**DRB23-0979**

**1212 Lincoln**

**citizenM Hotel**

**Delete Condition I.C.5.f. of  
2016 Order**

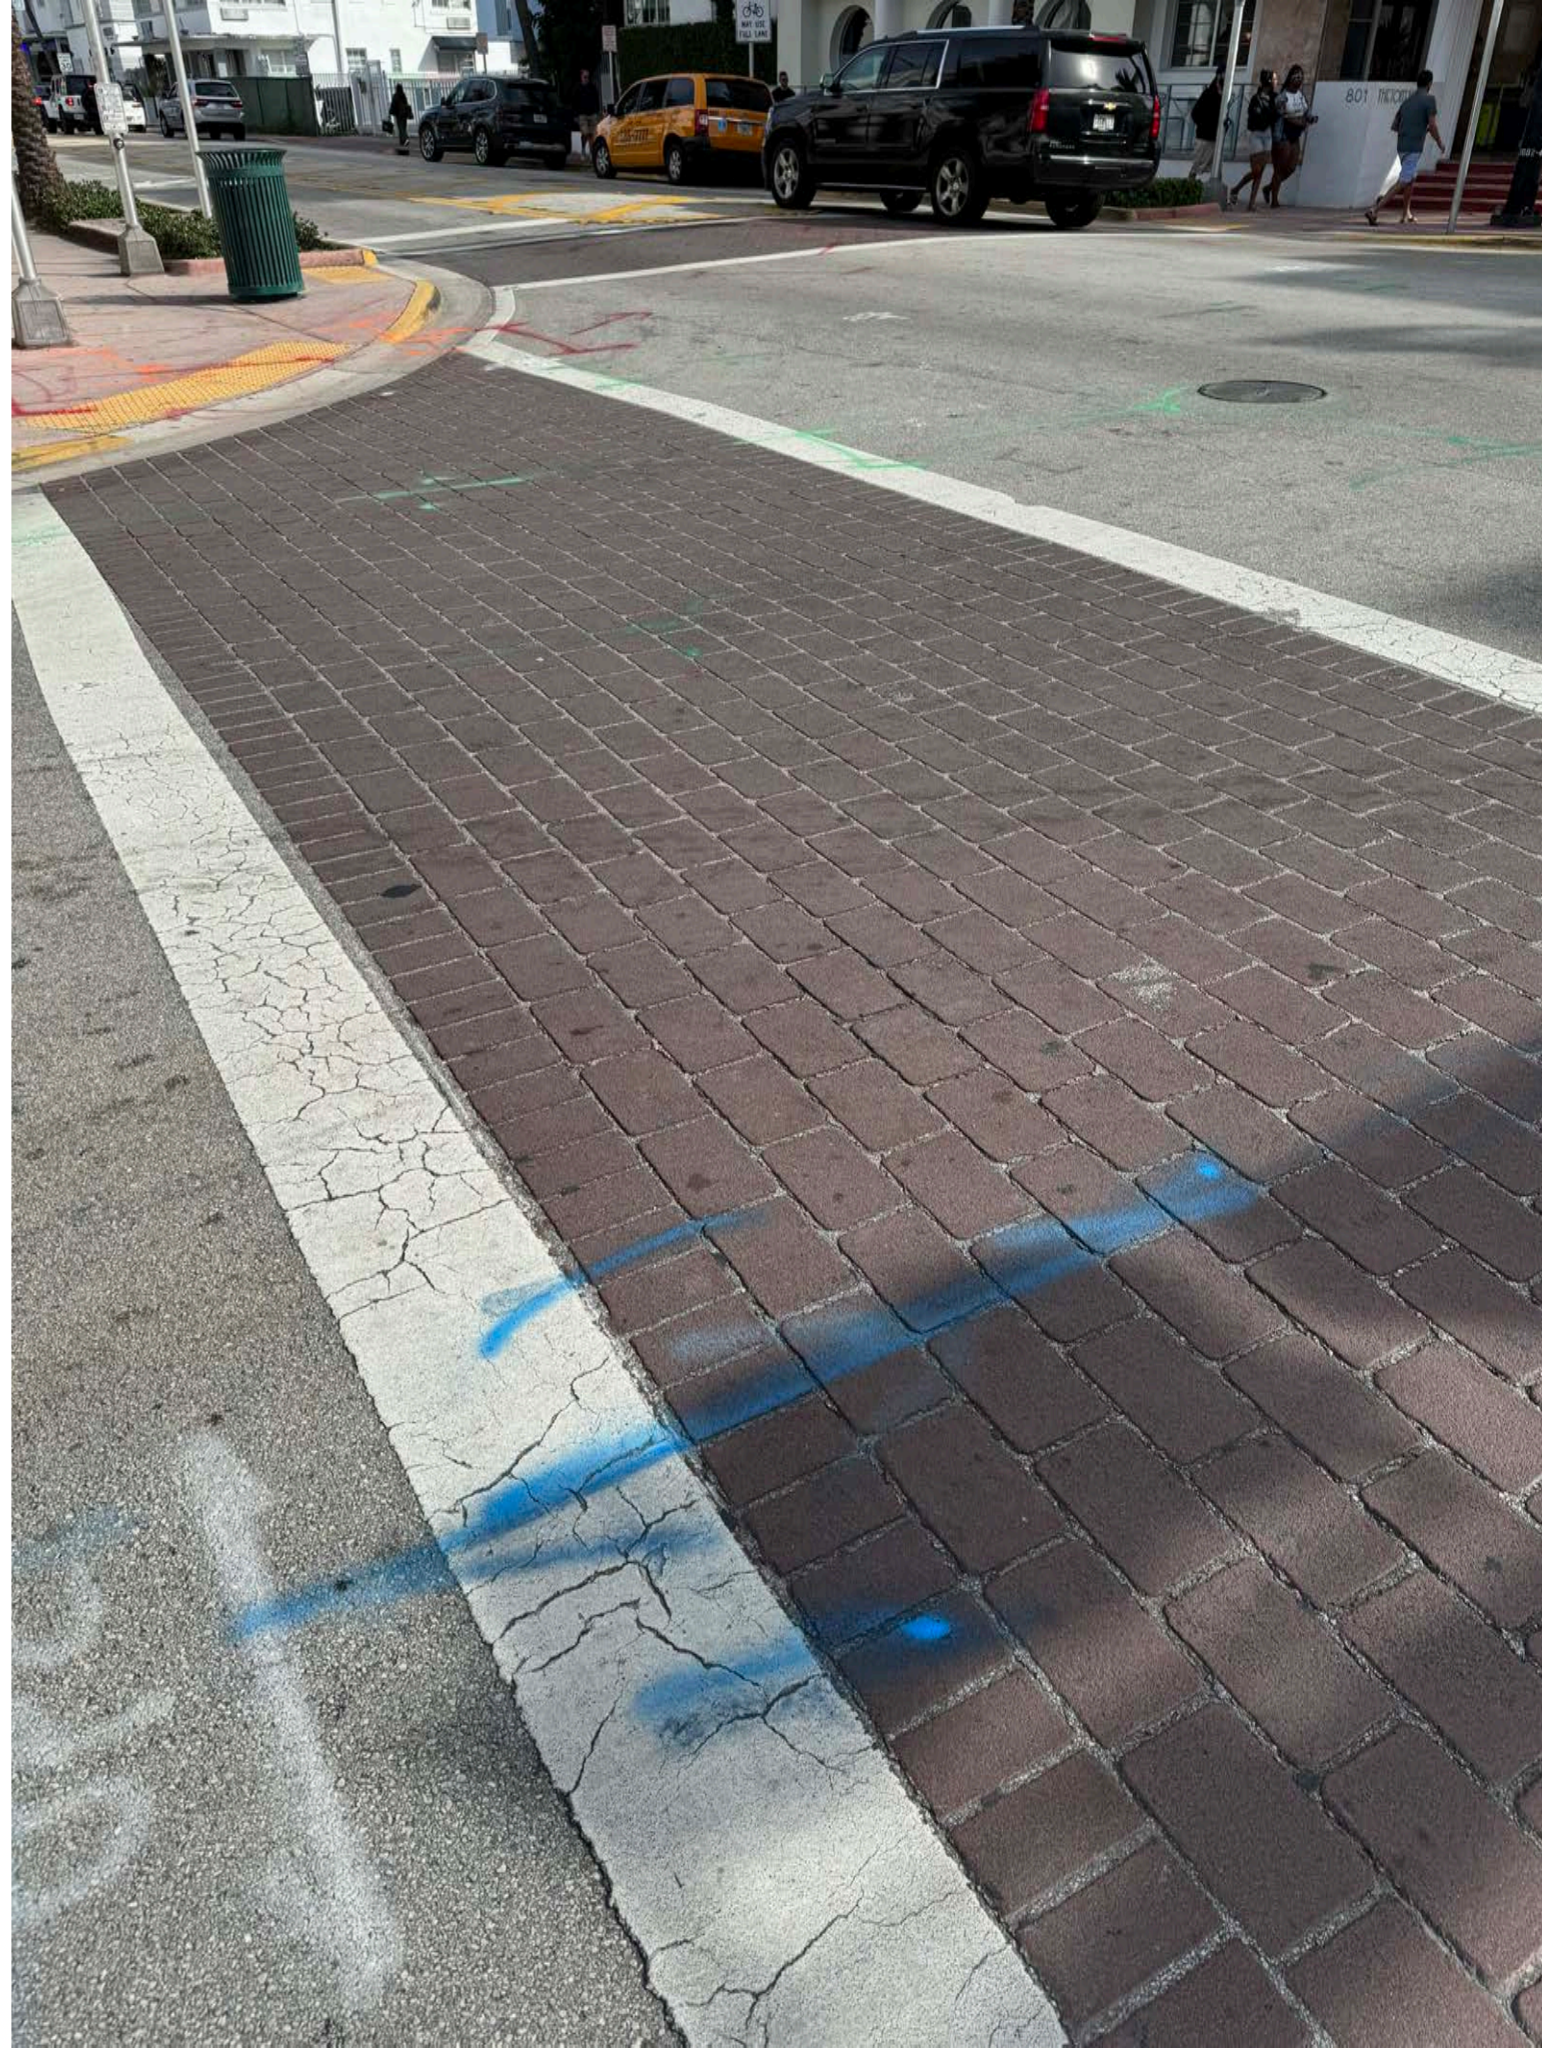
FDOT Will Not Accept Any  
Concrete/Pavers in its Right of Way

Stamped Asphalt is Only  
Acceptable Material
